1. East Sumner Apartments Phase I

PLN-2021-0043

REPORT TO THE DESIGN COMMISSION
from the COMMUNITY DEVELOPMENT DEPARTMENT

Permit Number: DR-2021-0043

Buildings 1 & 5 - Front Elevation (Building 4 Mirrored)

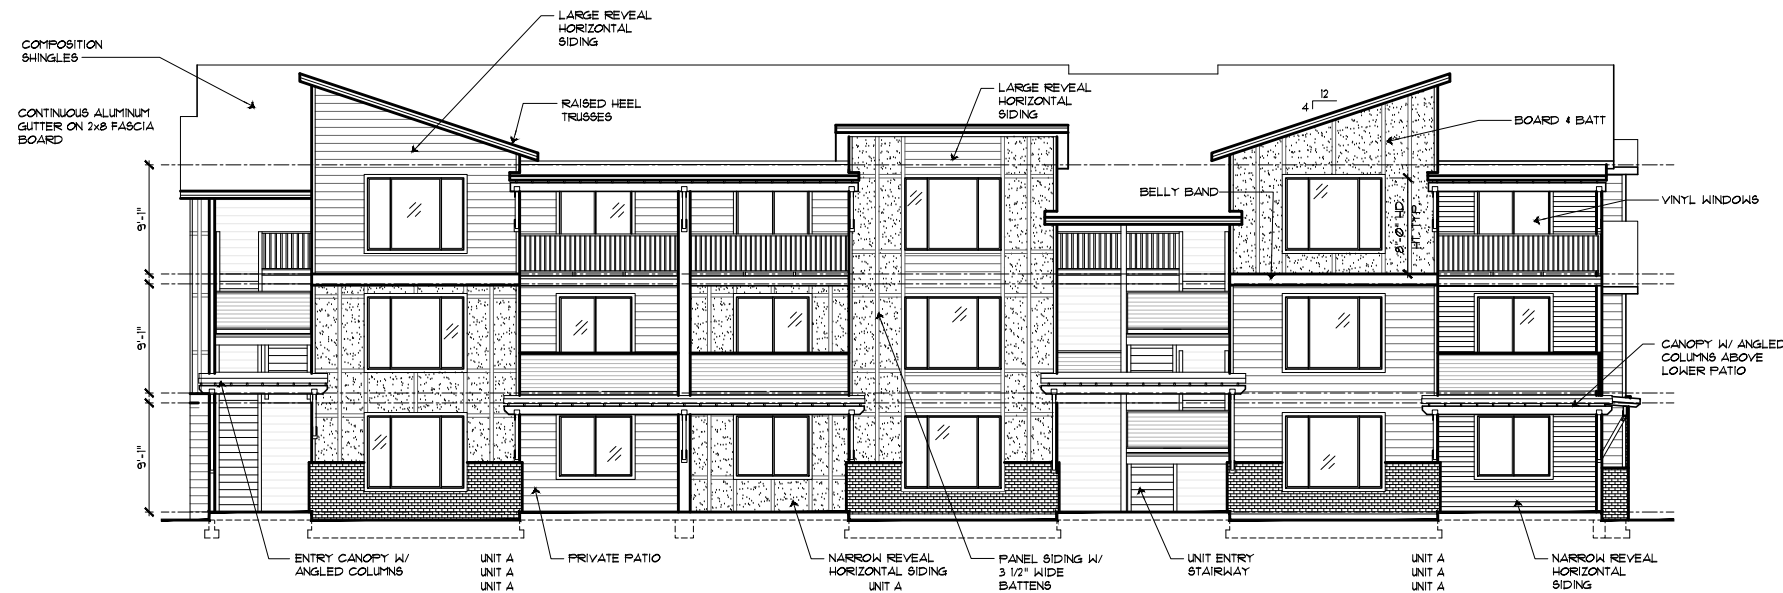
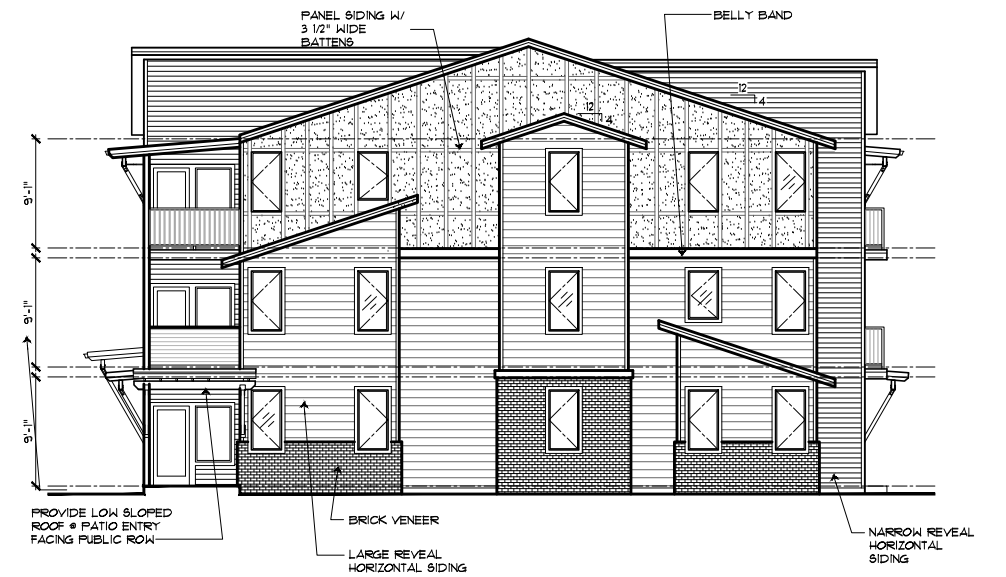
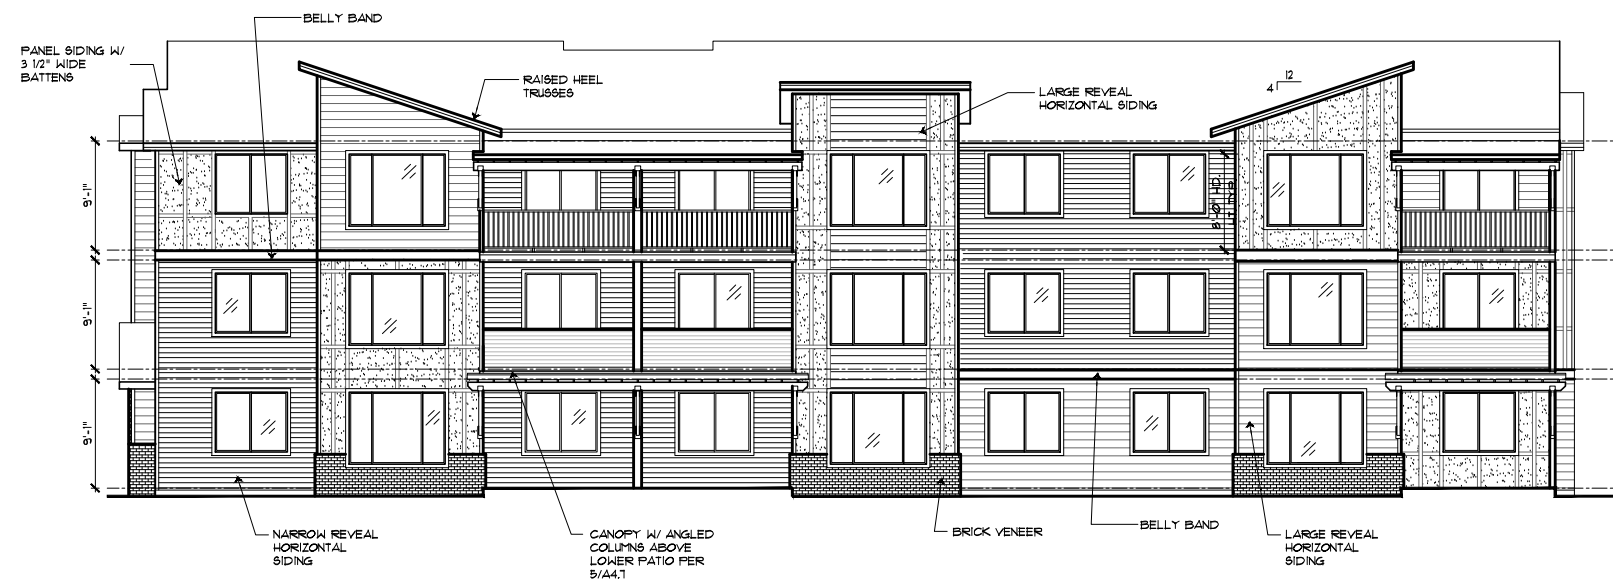
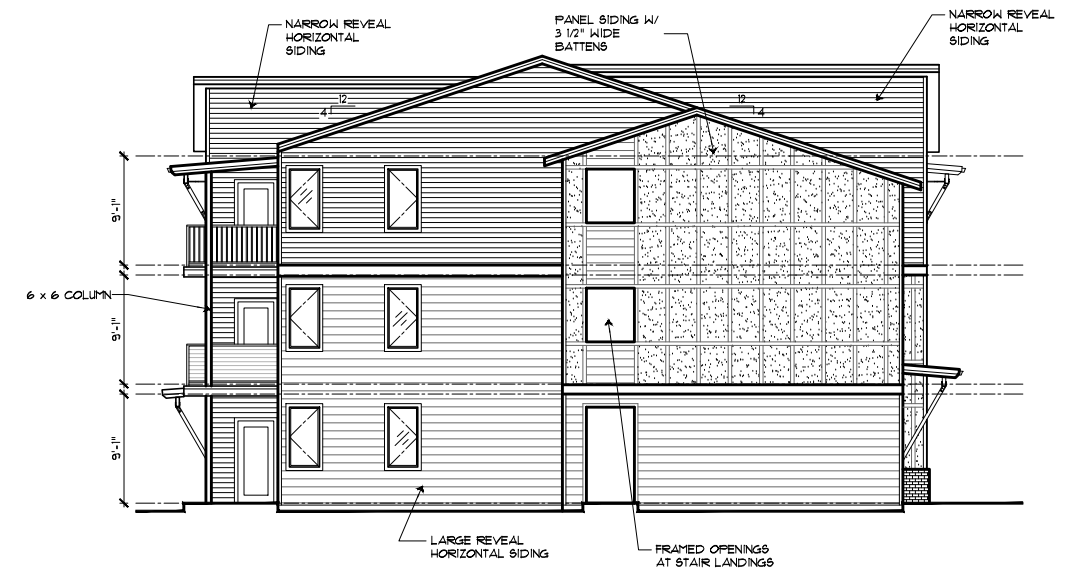
This project also proposes a design to use external stairwells which is not consistent with the intent of this guideline, which encourage stairwells to be designed internally. A 14-foot-wide

A secondary stairwell is proposed on buildings 1, 2, 3, 4 & 5. Both external stairwell structures are visible from the front, with the stair side elevation showing a building façade with framed open window openings and a roof awning extends slightly from the facade where the entrance to the stairwell lies. Applicant proposes to add a decorative framed window area above the first-floor deck railings to better enclose the exterior stairs; however, staff encourages alternative design consideration be taken. **To fully meet subsection b) of this guideline, staff recommends the condition that stairwells are designed fully enclosed. This condition will be listed under this guideline as 1.b.**

The Side Elevation provides variety by changing rooflines, however repetition of variety should reflect along both side elevations. Color changes alone does not provide the intended variety

Buildings 2 - Front Elevation (Building 3 Mirrored)

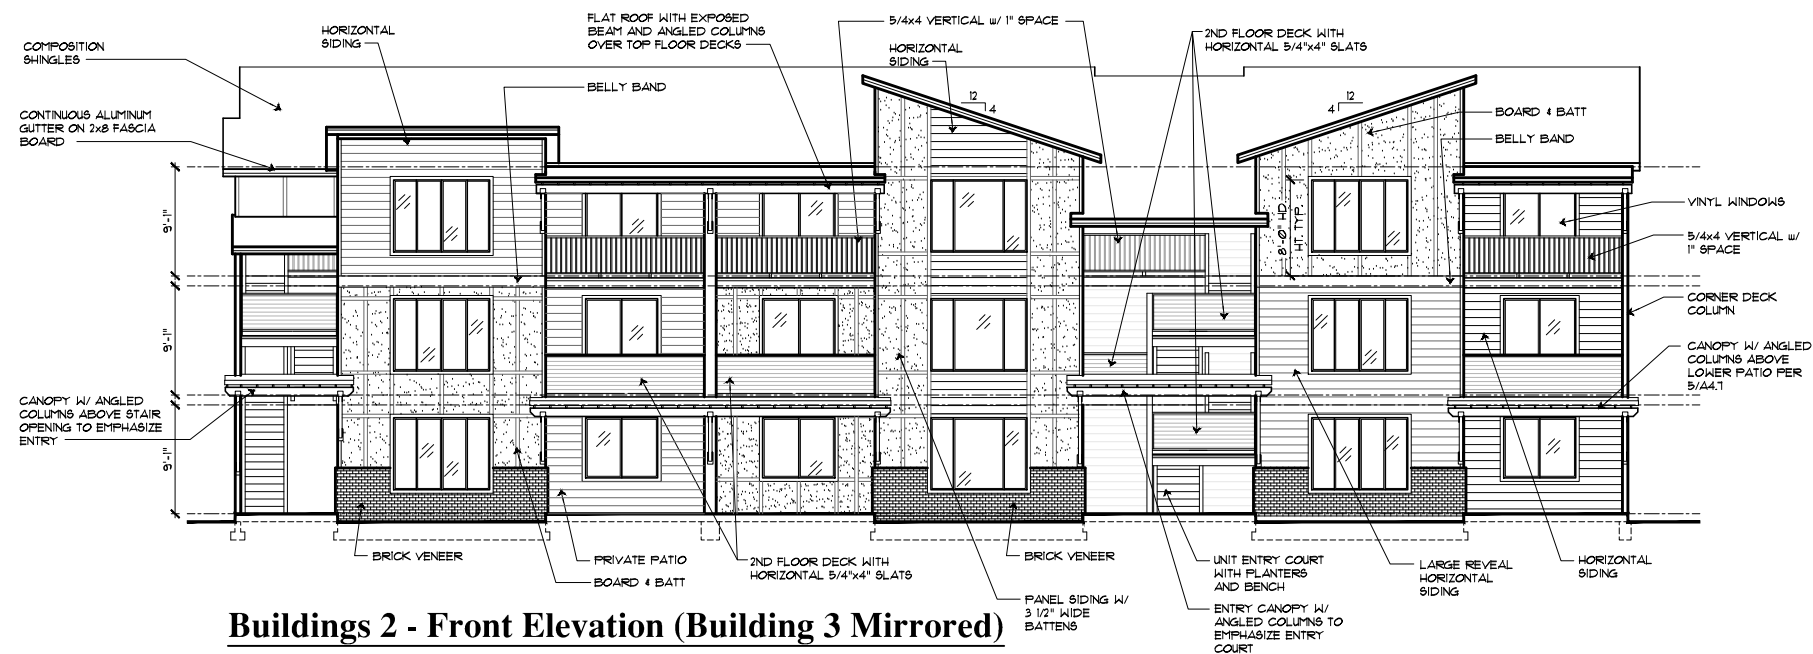
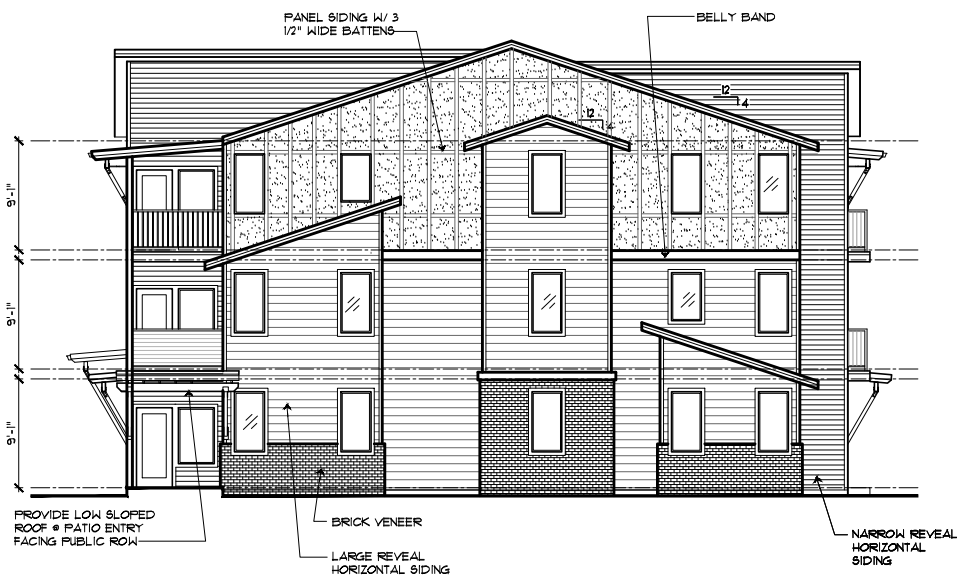
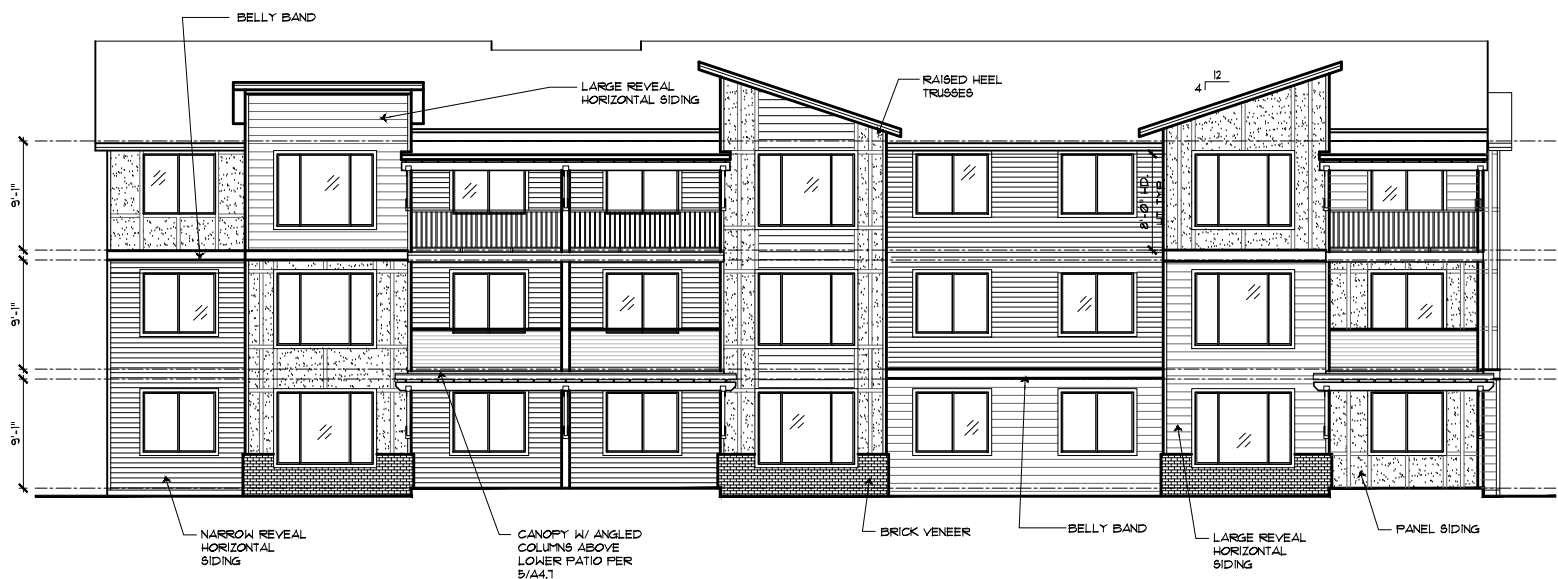
The Side Elevation provides variety by changing rooflines, however repetition of variety should reflect along both side elevations. Particularly, the interior side elevations.

Building modulation at the pedestrian scale needs to be considered. Color changes alone does not provide the intended variety,

- i. ***The internal side elevations for buildings 2&3 need to achieve a more distinct modulation, staff feels that the varying rooflines and exposed awnings provide a more top and bottom feel and encourages the use of more masonry or window treatments to earn the full point. Under the diversity design***

guideline below (DG 3.7.3), a condition may require building materials change that will satisfy this guideline.

Building 6 - Front Elevation

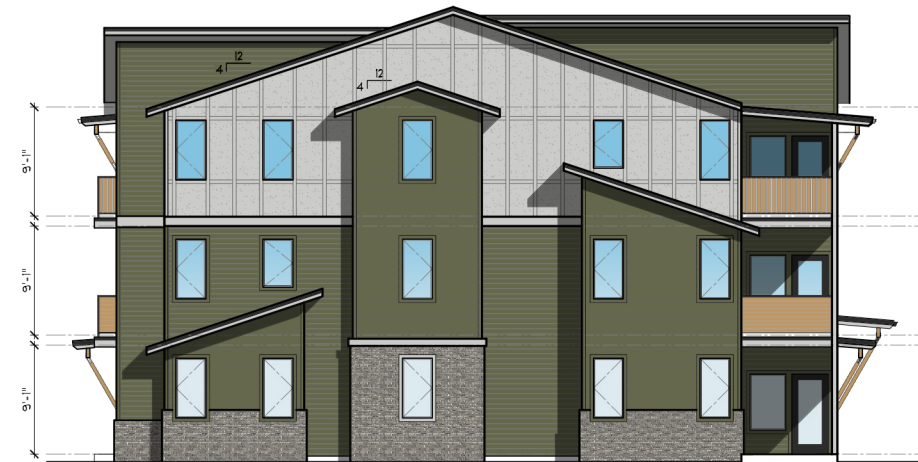
- i. *The internal side elevations for building6 needs to achieve a more distinct modulation, staff feels that the varying rooflines and exposed awnings provide a more top and bottom feel and encourages the use of more masonry or window treatments to earn the full point. Under the diversity design guideline below (DG 3.7.3), a condition may require building materials change that will satisfy this guideline.*
